**PARISHES OF WICKHAM MARKET, HACHESTON, CAMPSEA
ASHE, PETTISTREE AND MARLESFORD**

EDF Sizewell C

PARISH TRAFFIC MITIGATION PROPOSALS

WORKING DOCUMENT

Fig. 1 Areas of Concern in Campsea Ashe (circled red)

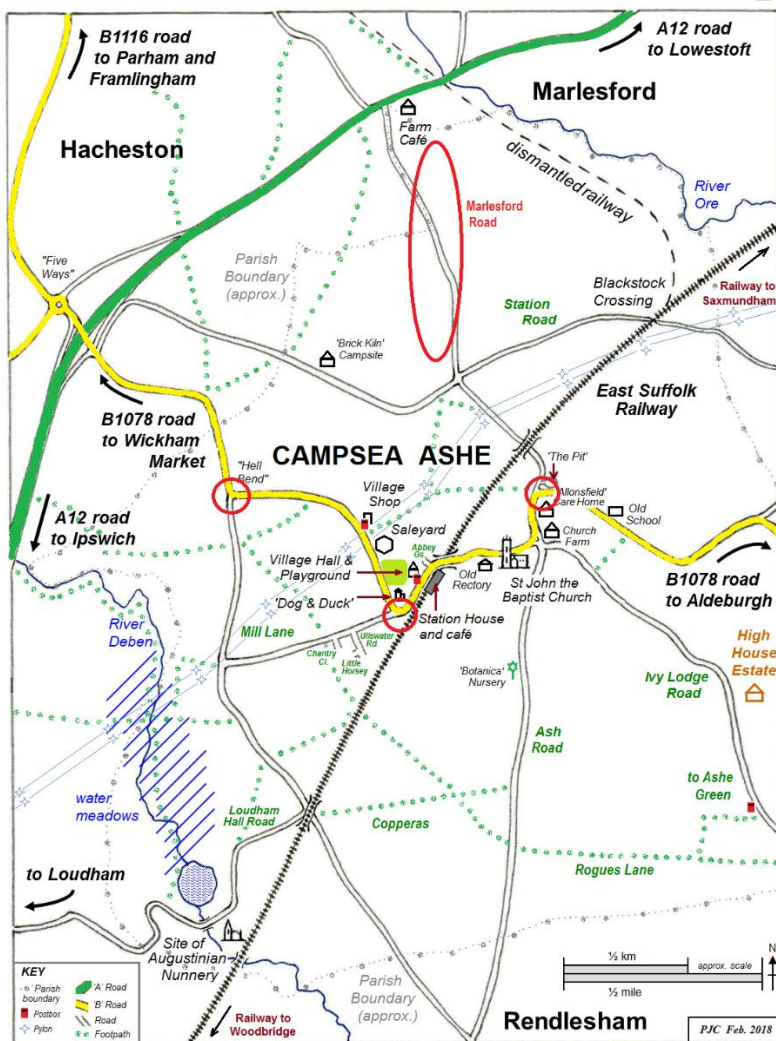
22. As outlined above, there are concerns that the intensification in the use of Bentwaters as a storage/transit depot serving SZC will add increased HGV pressure to the B1078. The B1078 between its junction with B1116 and Campsea Ashe is inappropriate for HGV use. The Parishes preference is for this route not to be used by SZC HGV traffic, but we have seen no alternative proposals from EDF.

23. The proposed southern Park and Ride site is located to capture traffic arriving from the west via the B1078 in addition to traffic arriving from the south but is also likely to attract traffic arriving from the east and south-east which will pass through Campsea Ashe. This would result in yet more pressure on the B1078 and unclassified roads in the village.

It is to be expected that the small lanes in and around Campsea Ashe village such as Ash Road, Station Road and the lane leading to the A12 at the Farm Café will be at risk from rat-running.

The B1078 is a narrow and winding road with many narrow areas and sharp corners where it is not possible for a car and an HGV to pass, let alone two HGVs. Poor visibility at the corners compounds the problems and dangers. These points are illustrated in Fig. 1 below.

Fig. 2 The Main Pettistree “Rat Run”

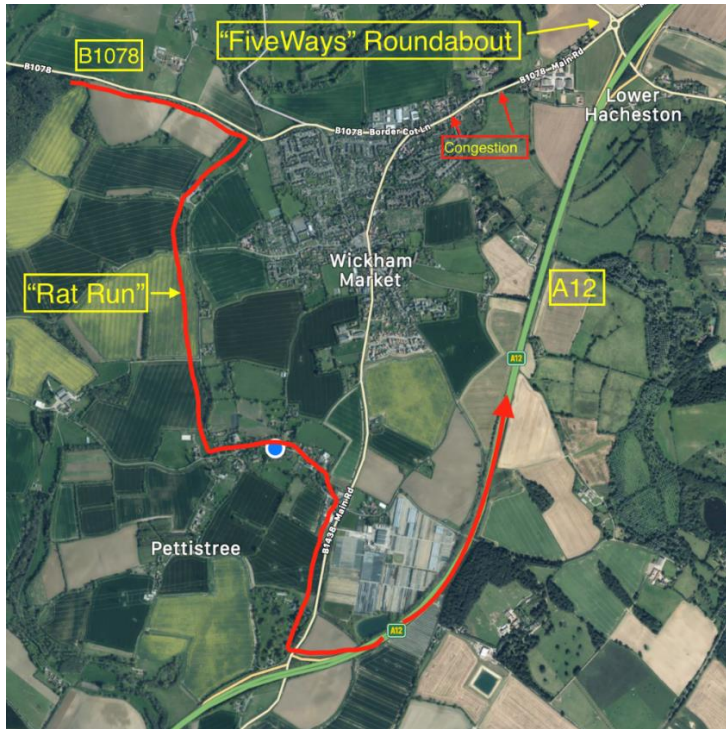
The effects of “rat runs” on the communities surrounding the SP&R have been highlighted in consultation responses by the Parishes (particularly Pettistree).

It is welcomed that HGVs going to Sizewell will be tracked and will not be allowed on the B1078. However, congestion is expected from workers’ cars and light delivery vans where the B1078 approaches the 5-ways roundabout having been joined by the B1438 passing through WM. Non-Sizewell traffic including HGVs can be expected to want to avoid this congestion and there will be nothing to stop them cutting across between the B1078 and the B1438 or A12 through the lanes of Pettistree, many of which are single track with no pavements, footways or street lights. Non-Sizewell cars and light vans will use the same rat runs since they will not be monitored like the HGVs.

The recommendation is that EDF and SCC apply pressure to providers of data to Sat/Nav companies to ensure that potential “rat runs” are marked “Unsuitable for HGVs” and appropriate signage should be erected on potential “rat run” lanes.
